Access Compliance Report Public Rights-of-Way (Curb Ramps)

Intersection ID: 11674 Main Street: GRAHAM ST Cross Street: HEARN_PL Location:

Overall Compliance: No ADA ID: 4A02C1341BE9 Ramp Type: PerpDiag Initial Pass/Fail: Fail Severity Score: 13.75

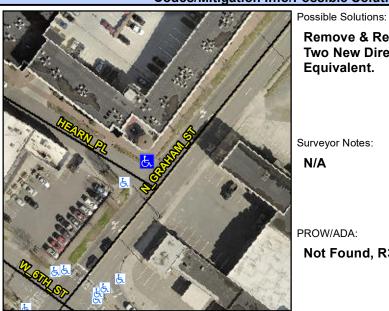
t Found, R304.2.2, R304.5.3

Comp	liance Description	Data	Comp	liance	Description	Data
N/A	Ramp Length (in)	28.0	No	Ram	Slope (%)	10.3
Yes	Ramp Width (in)	48.0	No	Ram	XSlope (%)	2.5
N/A	Flare Type LT	N/A	N/A	Flare	Type RT	N/A
N/A	Flare Slope LT (%)	N/A	N/A	Flare	Slope RT (%)	N/A
N/A	Flare Traversable LT?	N/A	N/A	Flare	Traversable RT?	N/A
N/A	Landing Length (in)	N/A	N/A	DWS	Provided?	N/A
N/A	Landing Width (in)	N/A	N/A	DWS	Contrast?	N/A
N/A	Landing Slope (%)	N/A	N/A	DWS	Length (in)	N/A
N/A	Landing X Slope (%)	N/A	N/A	DWS	Full Width?	N/A
N/A	Landing Curb? (Y/N)	N/A	N/A	DWS	Offset (in)	N/A
N/A	Shared Landing?	N/A				
N/A	Gutter Ponding?	N/A	N/A	Gutte	r Slope (%)	N/A
N/A	Gutter Lip Ht (in)	N/A	N/A	Gutte	r X Slope (%)	N/A
N/A	Painted X Walk1?	No	N/A	Paint	ed X Walk2?	No
	X Walk 1 Direction	To SW		X Wa	lk 2 Direction	To SE
N/A	X Walk 1 Width (in)	N/A	N/A	X Wa	lk 2 Width (in)	N/A
	X Walk 1 Slope (%)	1.8		X Wa	lk 2 Slope (%)	4.5
	X Walk 1 X Slope (%)	1.5		X Wa	lk 2 X Slope (%)	4.6

HEARN Street 1 Name Stop Condition-Street 2 StopSi Street 2 Name **GRAHAM** Stop Condition-Street 1 No **Remove & Replace Curb Ramp With Two New Directional Ramps or** Equivalent.
